MagIQtouch WI-FI Kit P/No.118352.

This kit includes a WIFI module with upgraded electronics P/No.118291-Y10. The WIFI module no longer requires to be powered by a plug transformer and is not provided in this kit. A 10m cable is supplied in place of the 20m cable.

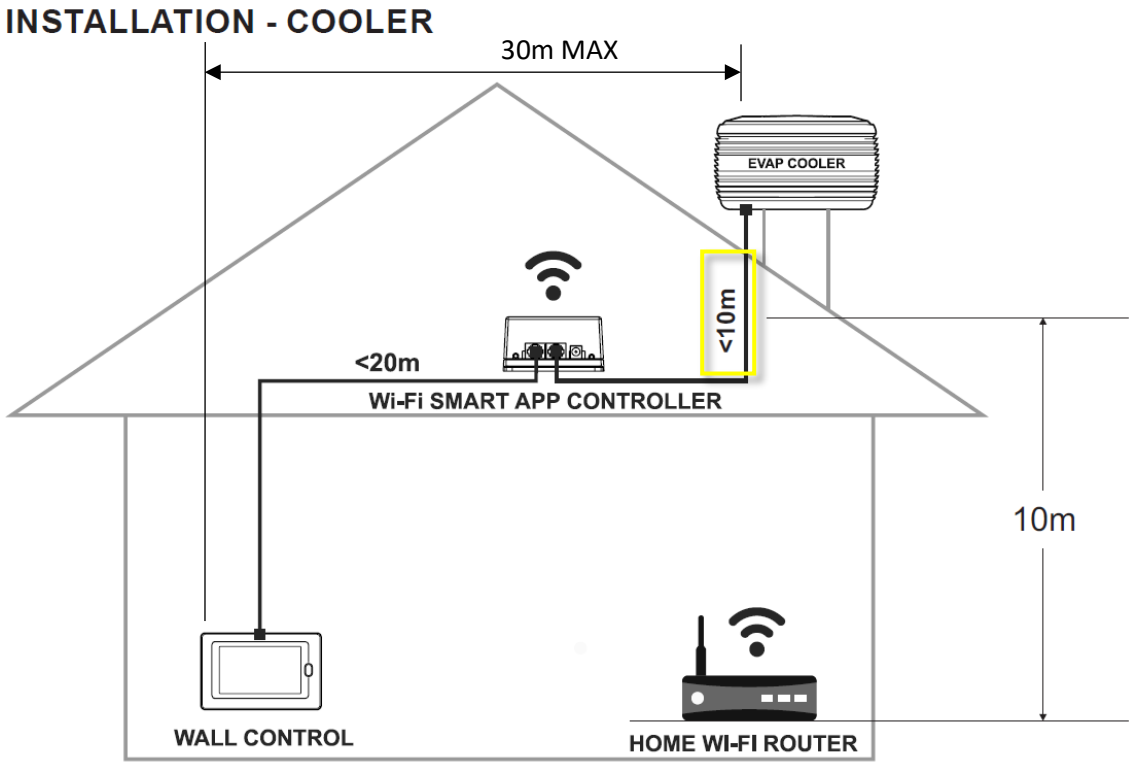
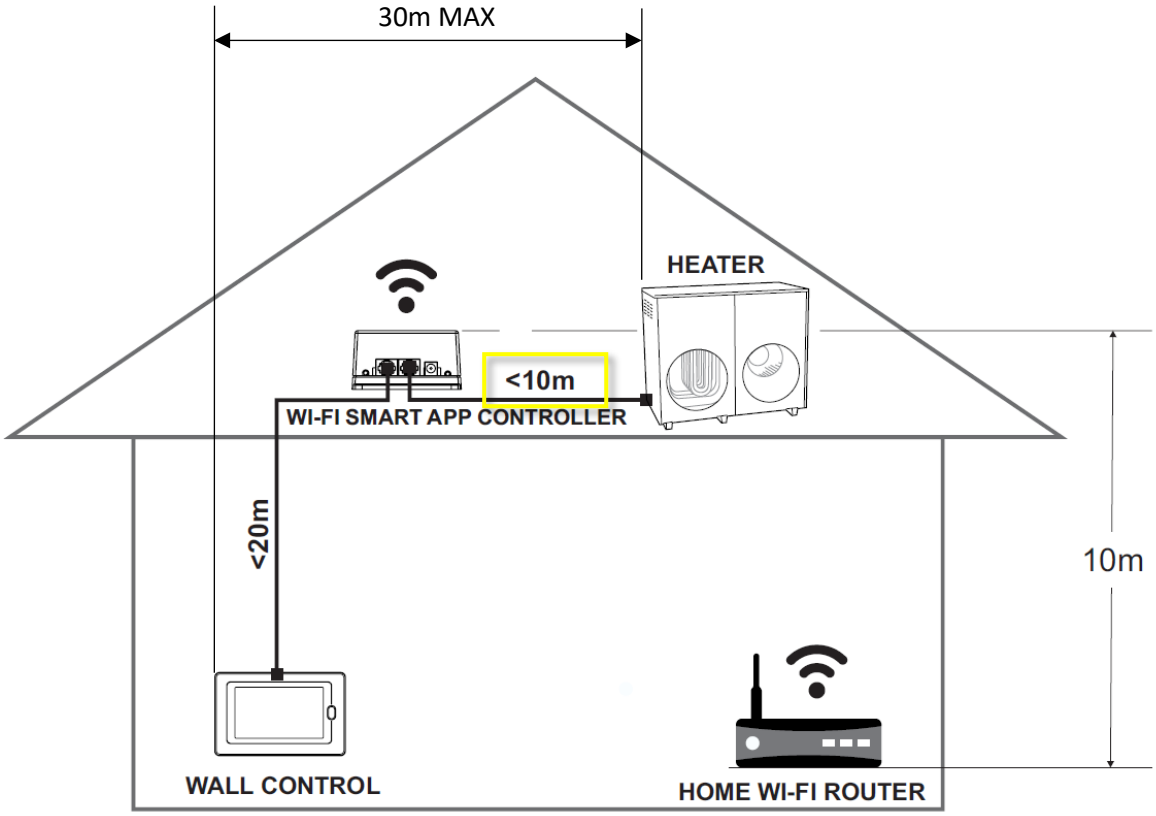
The new WIFI module gets its power from either the heater or cooler directly through the communications cable.

The maximum cable run from the heater or cooler appliance to the MagIQtouch wall controller, including the WIFI module can, be no longer than **30m.**

A plug transformer can still be applied to the upgraded WIFI module. This will increase the cable run from the heater or cooler appliance to the MagIQtouch wall controller, including the WIFI module to **40m max.**
